**Re: Azar-Menaul Townhomes, Grading and Drainage Plan
Engineer's Stamp Date 5/17/2015 (H22/D078)**

Subject: FW: Indian Ridge Subd.

Subject: FW: H22D078 - Azar-Menaul Townhomes - Stamp Date 1-7-16

**RE: Revised Grading Plan
Azar Apartments
(Tract 2A Indian Ridge drb#1007786)
Albuquerque, New Mexico**

1 SITE WALLS PLAN
Scale: 1" = 30'-0"

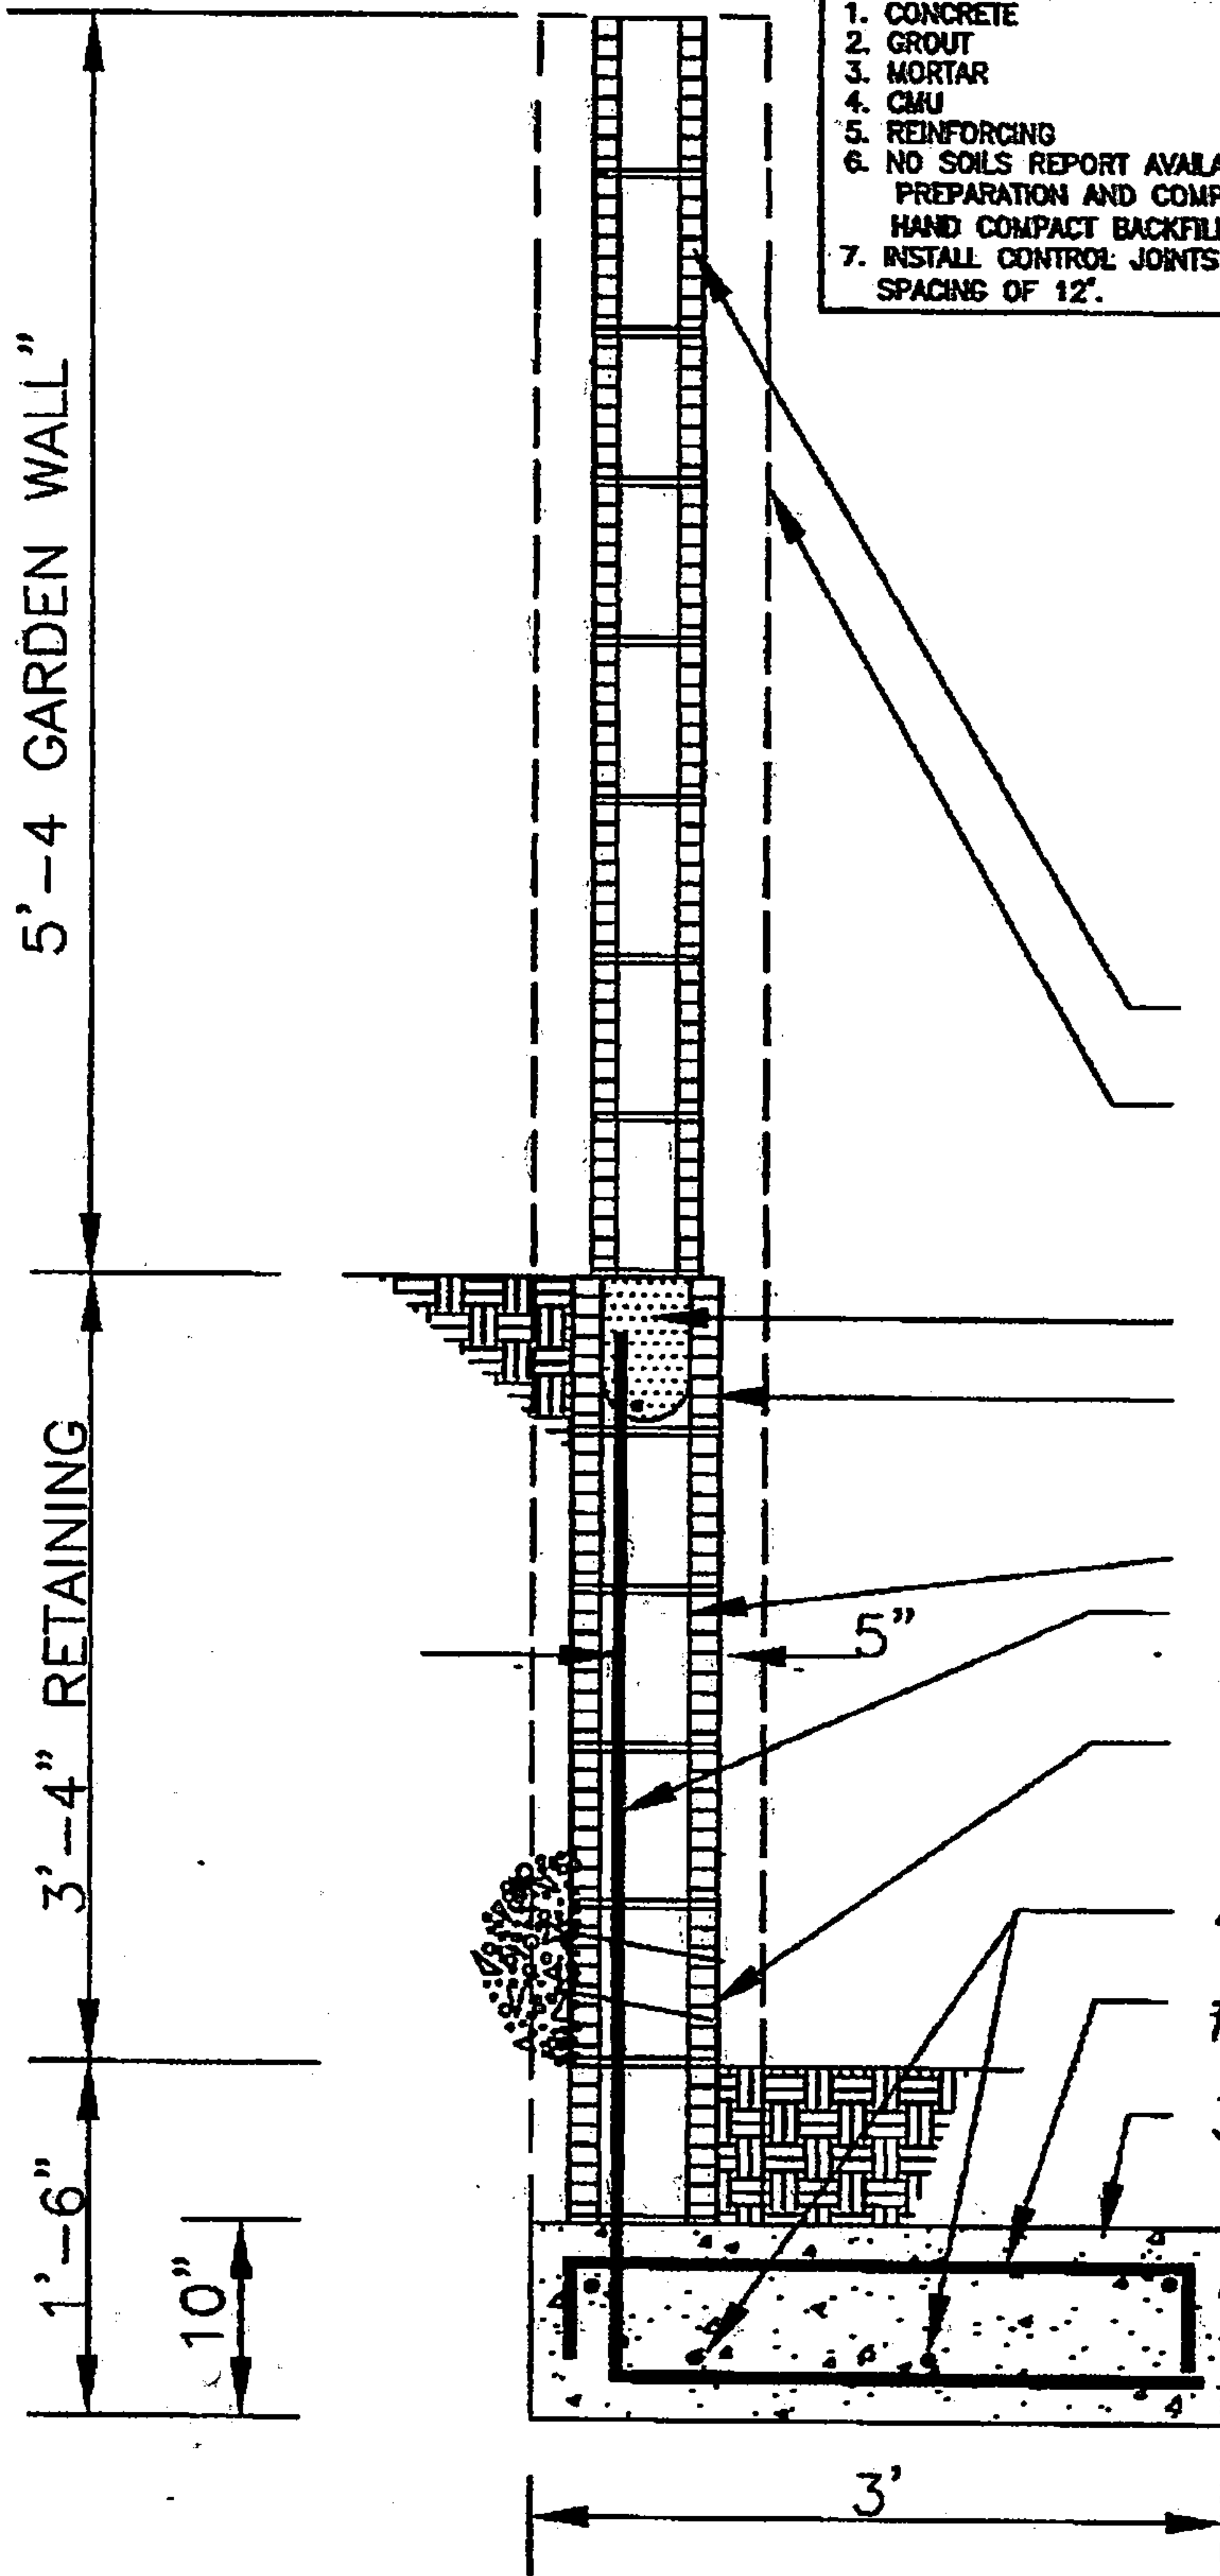
- Provide a detail for all retaining walls.
I HAVE ATTACHED, THESE ARE PART OF SEPARATE PERMIT
- How will flows leave the back yards? Provide turn blocks 3" above grade.
WE HAVE ADDED TO NOTE TO PLAN AND ADDED TO NOTE#3
